WINCH UPGRADE

New Handle on a new winch
	Winch Break Counter Bearing over the shaft

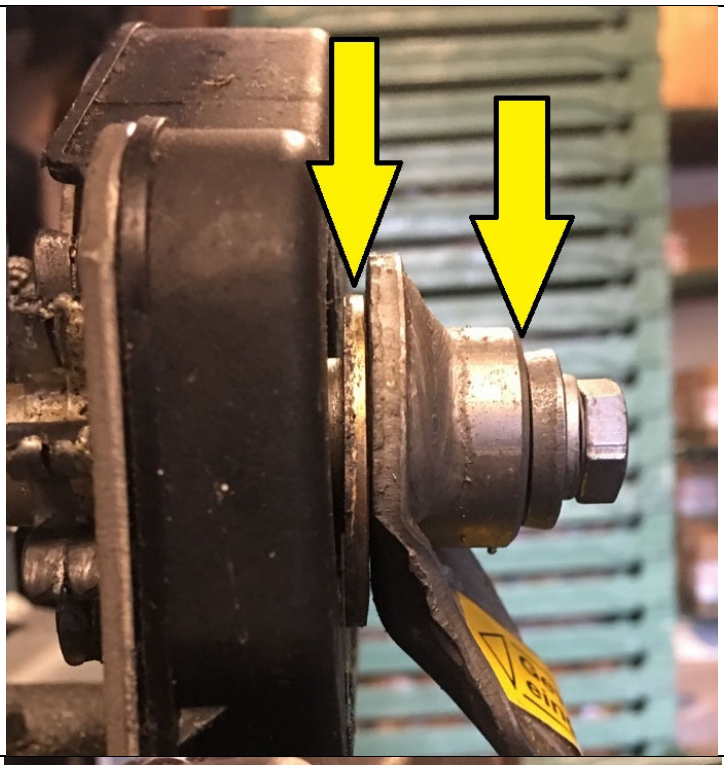
If the bolt that holds the handle has gotten loose and the handle has backed off, the available clearance would allow the handle to come back out until it touches the thick washer

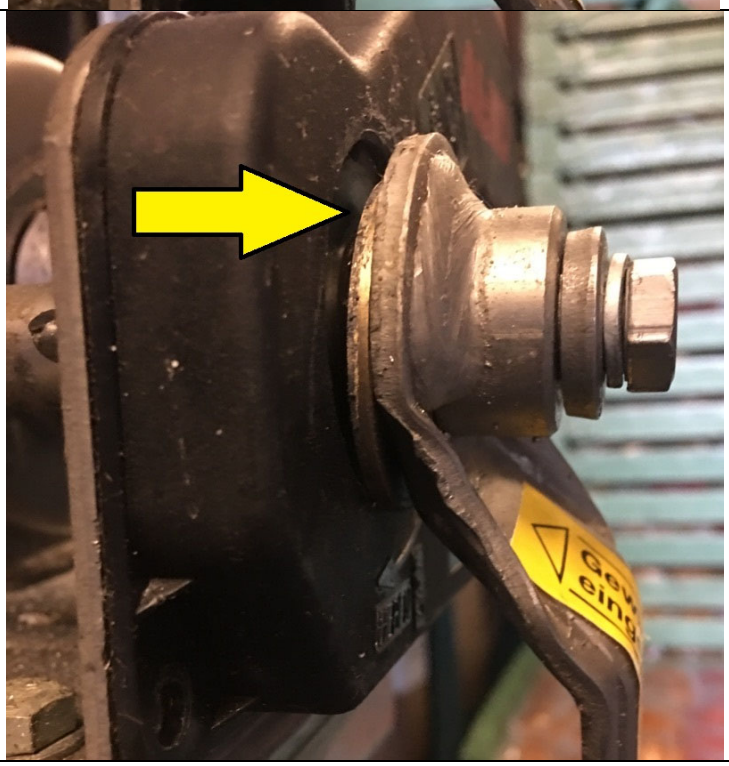
The Brake Disc comes off the shaft but the handle still secure. At this stage the winch will not click anymore unless the disk is reset in place in the shaft
